January 24, 1992  
LD-92-006

Docket No. 52-002

Subject: Response to NRC Requests for Additional Information

RESPONSE TO NRC REQUESTS FOR ADDITIONAL INFORMATION  
PLANT SYSTEMS BRANCH

Figure  
9.2.1-1

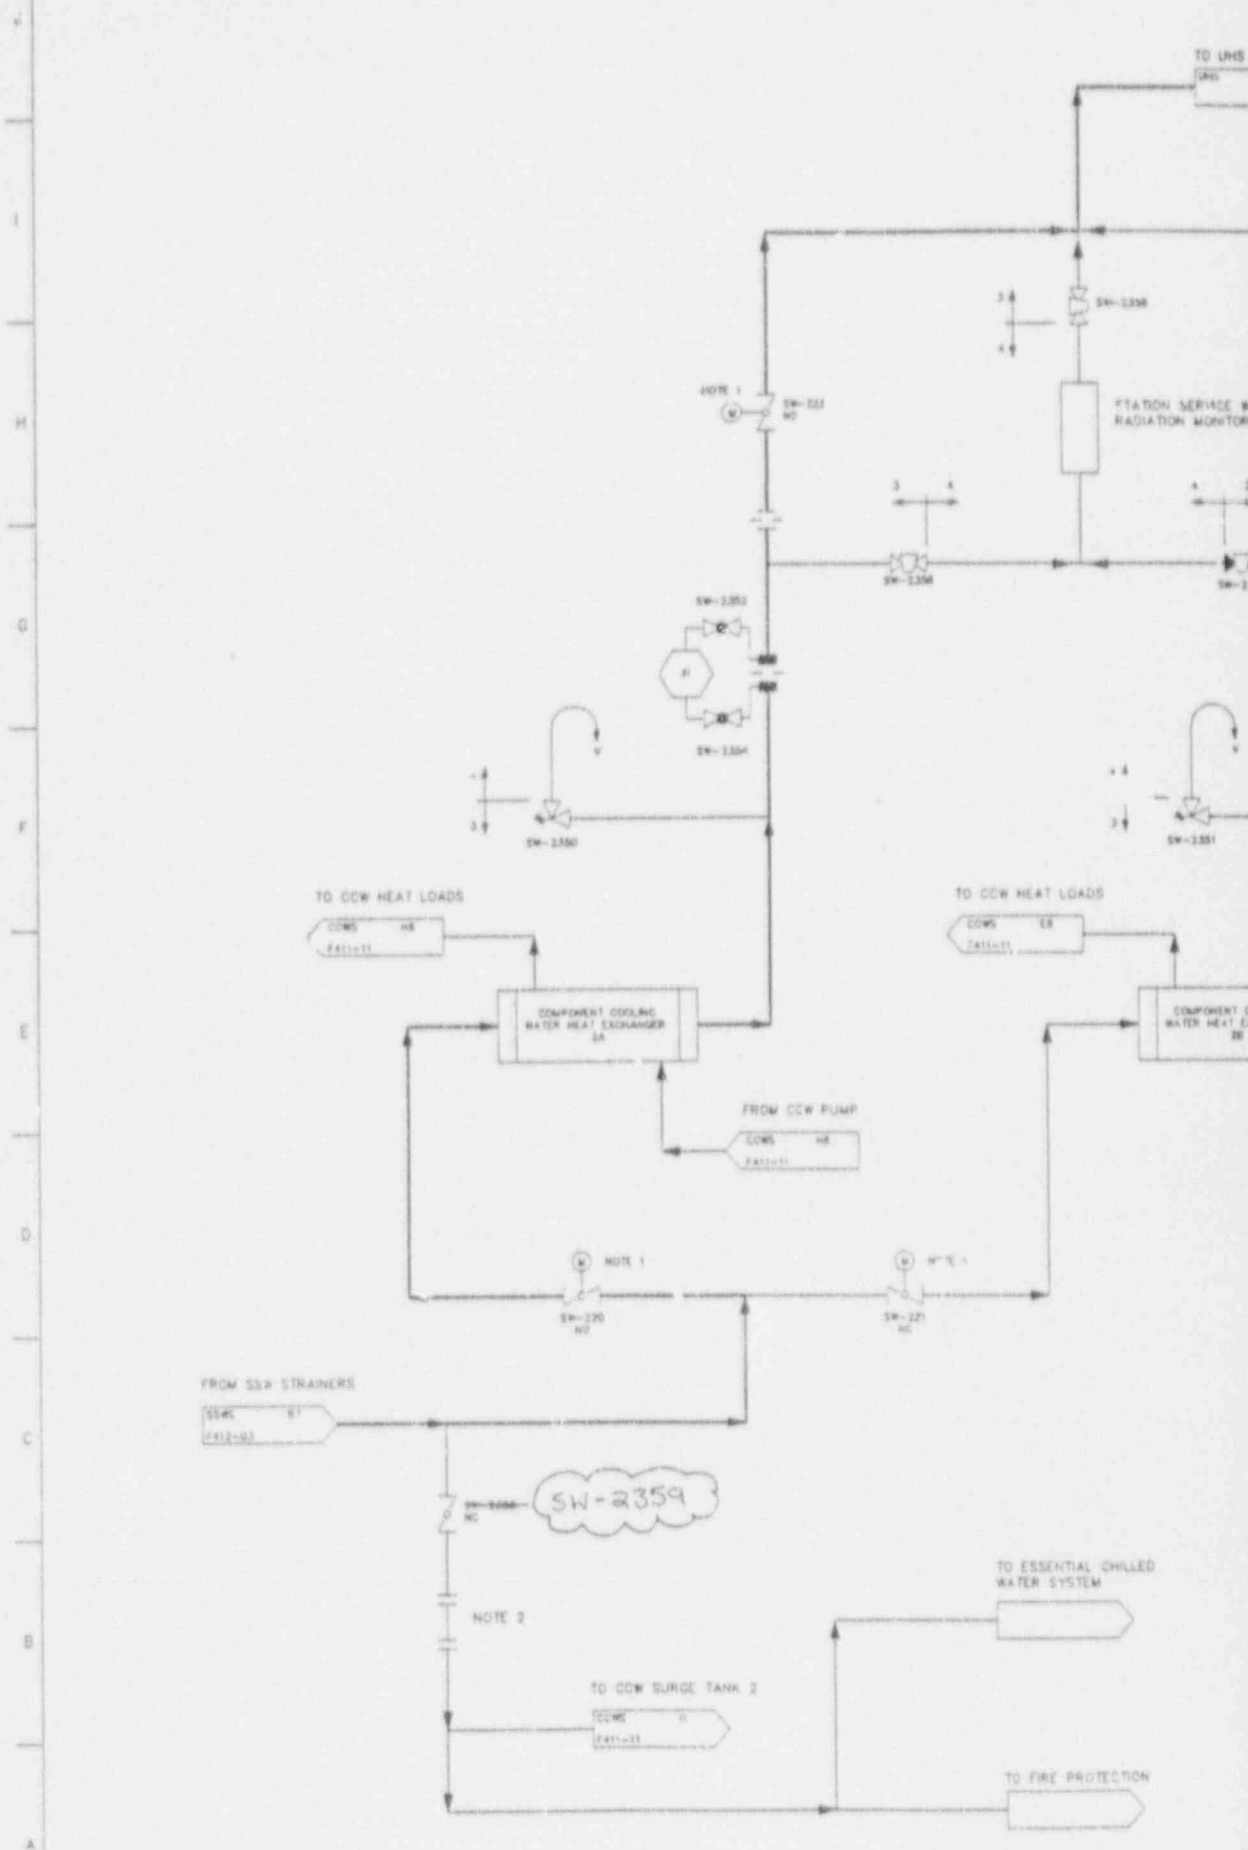
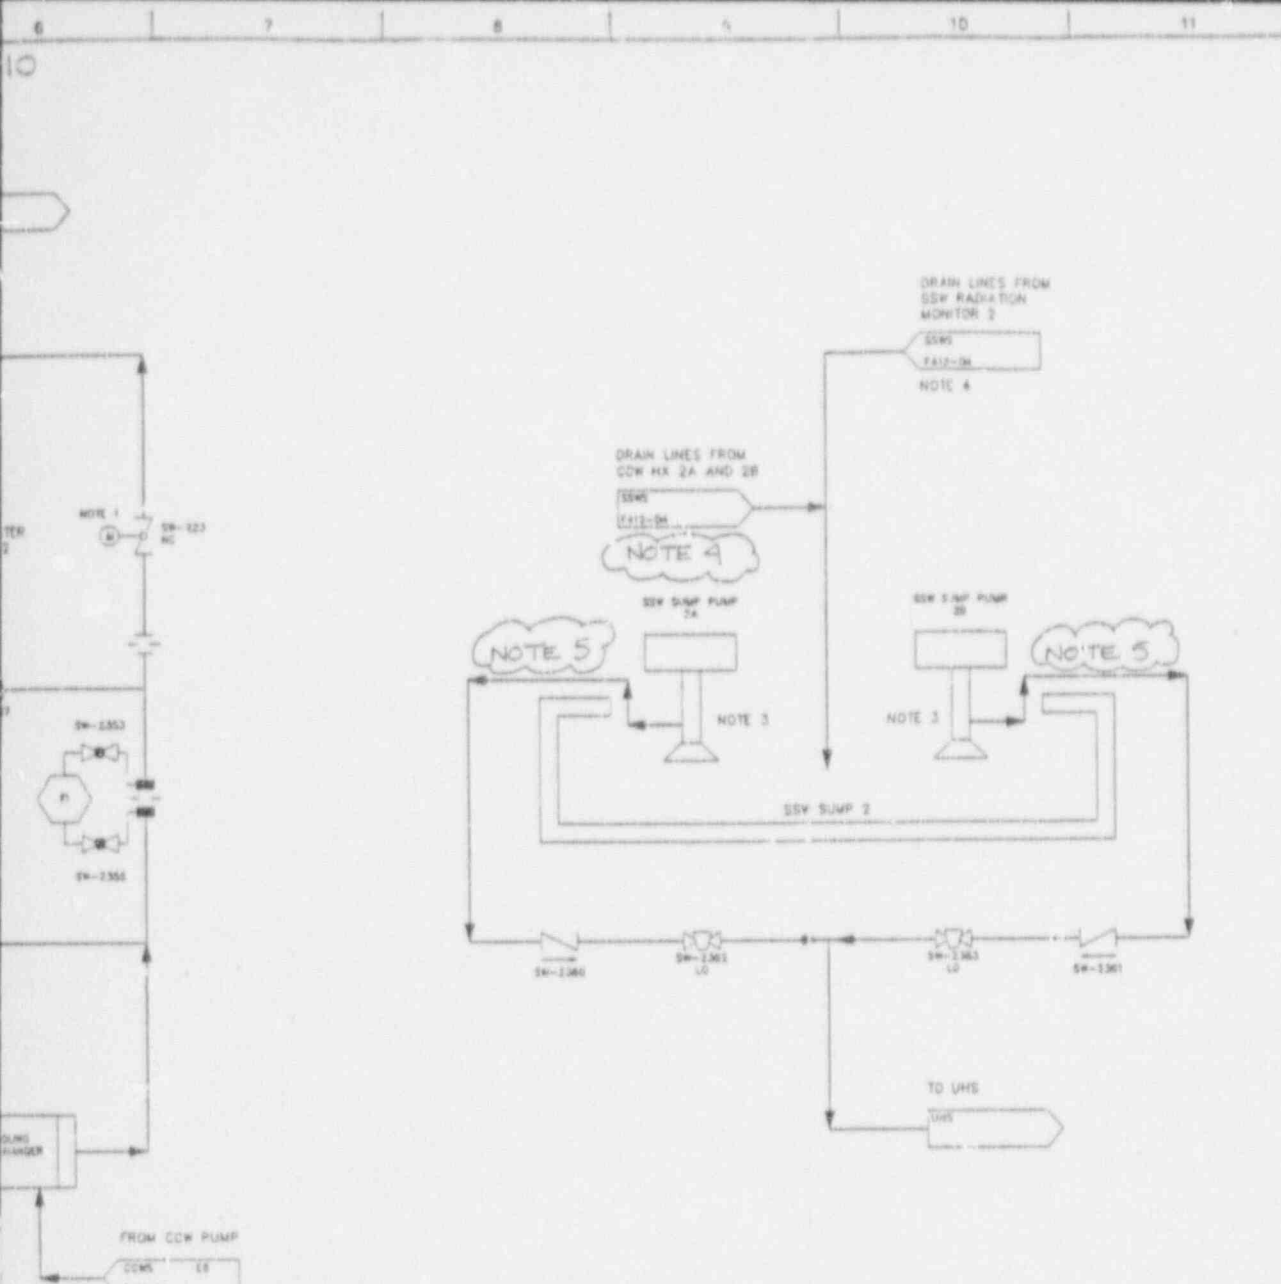
- c. Sheet 1 of Figure 9.2-1 identifies two valves that have been assigned the same number (i.e., SW-1356). A similar condition exists on Sheet 3 of Figure 9.2-3 with valve number SW-2356.

- c. The repetition of valve numbers SW-1356 occurs on Sheet 2 of Figure 9.2.1-1 and the repetition of valve number SW-2356 occurs on Sheet 4 of Figure 9.2.1-1. The valve numbers of the valves upstream of the removable spool piece should be changed to SW-1359 on Sheet 2 of Figure 9.2.1-1 and SW-2359 on Sheet 4 of Figure 9.2.1-1.

This response is being incorporated into CESSAR-DC Section 9.2.1, Station Service Water System. This response is reflected on the Station Service Water System Flow Diagrams as valve number changes on the valves upstream of the removable spool pieces. A markup of CESSAR-DC Figure 9.2.1-1 is attached.
